# Sheringham Shoal and Dudgeon Offshore Wind Farm Extension Projects

Addendum to the Flood Risk Assessment (Revision B)  
(Clean)

Document Reference: 14.31

Figure 1: 1 in 100 year plus 45% for climate change with OnSS platform level set at 28.23m AOD and NW access road

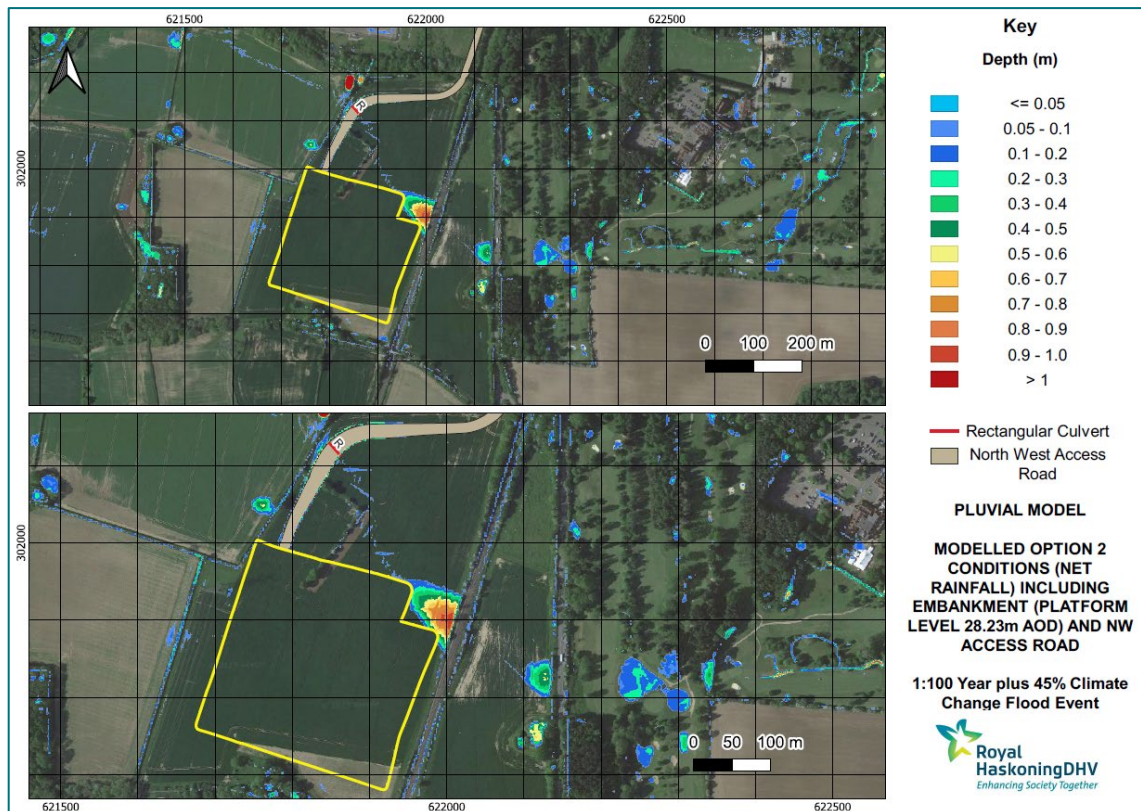
62. Comments were provided by the LLFA in their **Relevant Representation** [RR-064] with specific regard to the requirement for an update to the surface water hydraulic model for the Onshore Substation such that it applies the latest climate change allowances and provides an assessment of the change in flood risk.

67. Figure 9-23 of the **Annex 18.2.2: Onshore Substation Hydraulic Modelling Report (Revision B)** [document reference 14.34] is reproduced below as **Figure 1**. The results from this modelling scenario demonstrate there is minimal interaction between the Onshore Substation platform and North West (NW) access road and the surface water flood extent during the 1 in 100 year plus 45% climate change allowance event.

68. The results also confirm that whilst the flood depth adjacent to the Onshore Substation platform varies, it is not of a sufficient depth to result in flooding to the Onshore Substation platform. In addition, it confirms that the NW access road can be designed such that there is continued conveyance beneath it.

69. On this basis neither the Onshore Substation platform nor the NW access road will result in flooding to SEP and DEP. Furthermore, they will not result in displacement of surface water flooding such that there would be an off-site impact on surface water flood risk.

Figure 2: 1 in 100 year plus 45% for climate change comparison of changes in flood extent

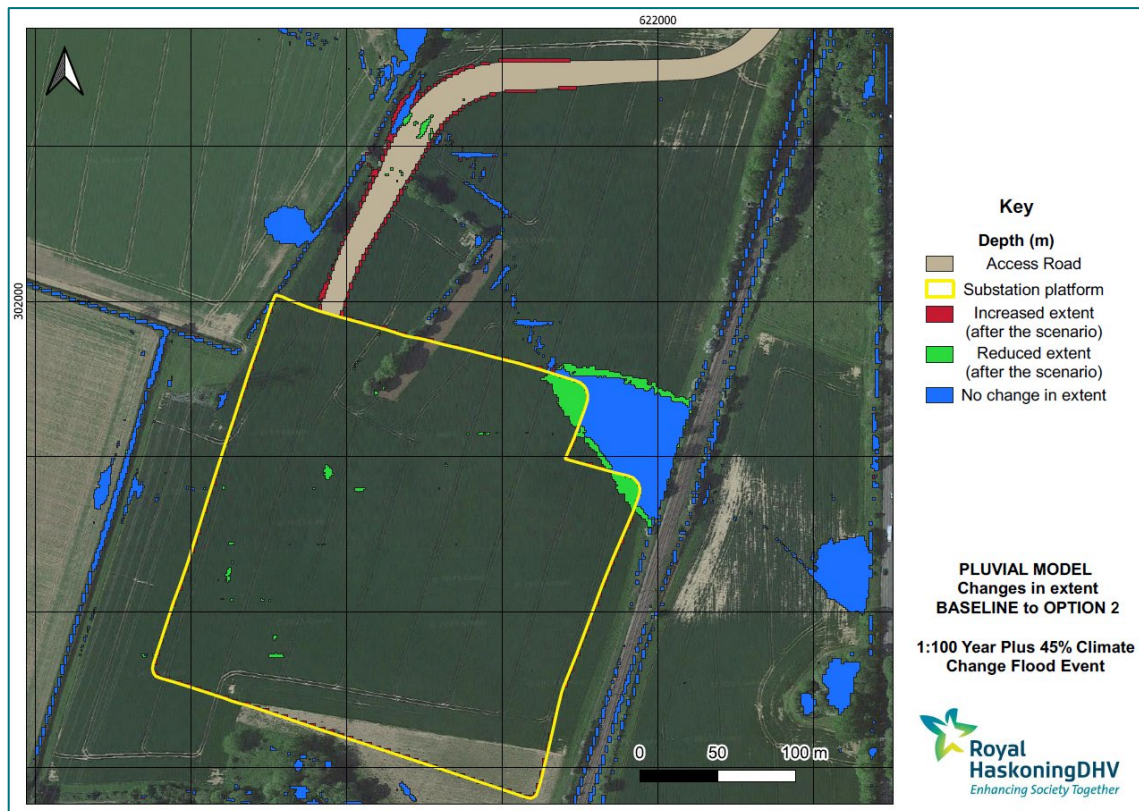
- 72. Figure 9-24 of the **Annex 18.2.2: Onshore Substation Hydraulic Modelling Report (Revision B)** [document reference 14.34] is reproduced below as **Figure 2** and demonstrates the change in flood extent following the construction of the Onshore Substation platform and NW access road.

73. While there is a reduction in the flood extent around the edge and within the footprint of the Onshore Substation platform, the results of the modelling indicate there is a slight change to the flood extent along the edges of the raised NW access road.

74. The reduction in flood extent can be attributed to the incorporation of the Onshore Substation platform within the model. By including it within the model, rainfall falling on the platform during an event does not contribute to the flooding as water from the impermeable or bound surfaces will be collected by the surface water drainage system to be implemented as part of SEP and DEP whilst the permeable or unbound areas will naturally infiltrate into the ground on the platform or adjacent to the NW access road.

75. A review of the results has confirmed the change in extent adjacent to the NW access road is very localised and does not extend beyond the immediate area and is related to a minor accumulation of surface water adjacent to the access road structure.

76. Upon review of this data, it is noted that the change in extent along the edges of the NW access road is a result of its representation within the model whereby surface water from the impermeable or bound surface of the access road is draining off the sides. However, the proposed drainage design for the Onshore Substation platform would capture this water within the surface water drainage system and therefore this flow would not exist.

77. It is also noted that there is no restriction of flow as a culvert below the NW access road has been included within the model. This is confirmed in **Annex 18.2.2: Onshore Substation Hydraulic Modelling Report (Revision B)** [document reference 14.34] which notes that the modelling included a 2.20m high culvert, primarily for modelling purposes. However, a review of the model results identified that during the 1 in 100 year (plus 45% for climate change) event the maximum water depth at the upstream extent of the culvert is likely to be approximately 0.23m. As such, a 2.20m high culvert would be considerably larger than that required to ensure the continued conveyance of surface water flow.

78. On this basis, it is concluded that the height of the culvert can be refined and reduced during the detailed design process to provide cover levels of between 0.3m and 1m from the top of culvert to the access road carriageway. This would ensure sufficient cover levels, appropriate to the type and nature of the vehicle loading in this location, whilst also maintaining surface water flow conveyance under the access road.

Figure 3: 1 in 100 year plus 45% for climate change comparison of changes in flood depth

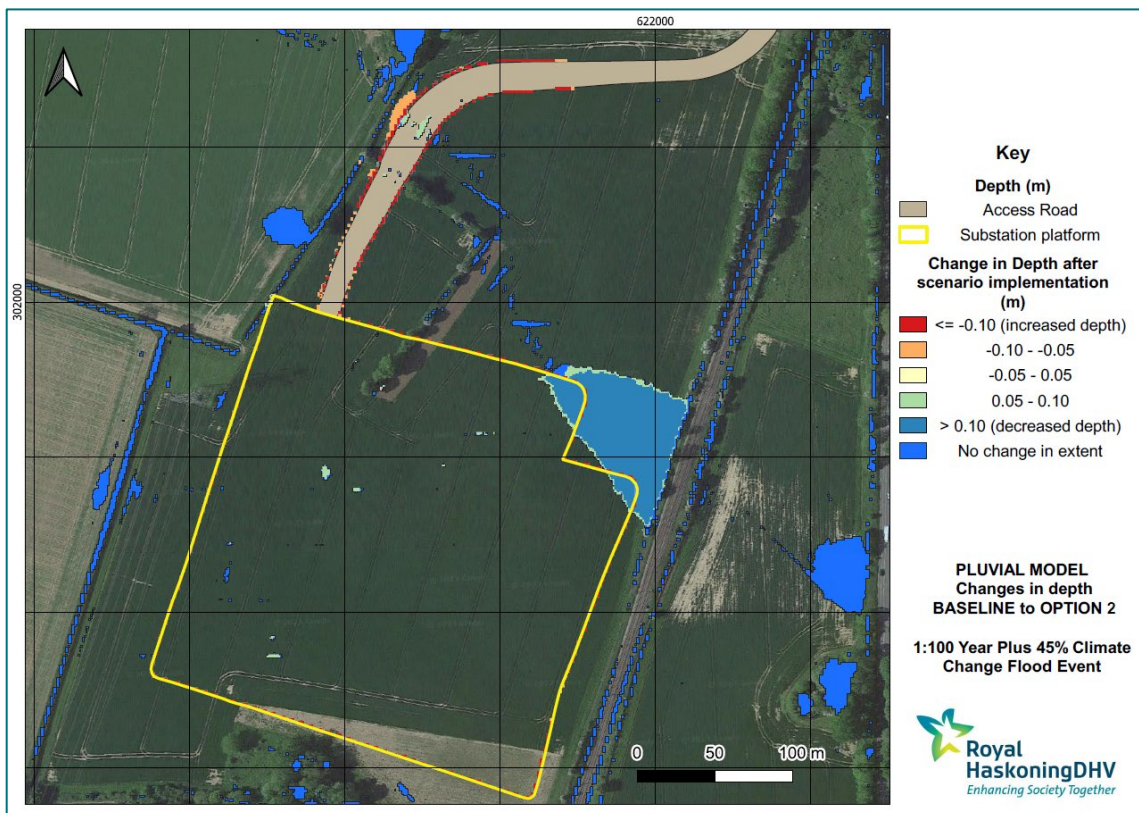
79. To provide greater clarity on the impact of the Post Construction scenario on surface water flood risk, the changes in depth have also been considered.

80. Figure 9-25 of the **Annex 18.2.2: Onshore Substation Hydraulic Modelling Report (Revision B)** [document reference 14.34] is reproduced below as **Figure 3**.

81. A comparison between the Baseline and Post Construction results demonstrates that any flood water which is displaced by the proposed Onshore Substation platform is relatively minor and will not result in a significant off-site risk. Furthermore, it also demonstrates there is a slight reduction in the depth of water pooling against the railway embankment.

82. As previously noted, this is likely to be due to the rainfall falling directly onto the Onshore Substation platform being collected from the impermeable or bound surfaces by the surface water drainage system to be implemented as part of SEP and DEP whilst the permeable or unbound surfaces will naturally infiltrate into the ground on the platform. Overall, this results in a reduction in surface water reaching the low-lying area adjacent to the railway line.
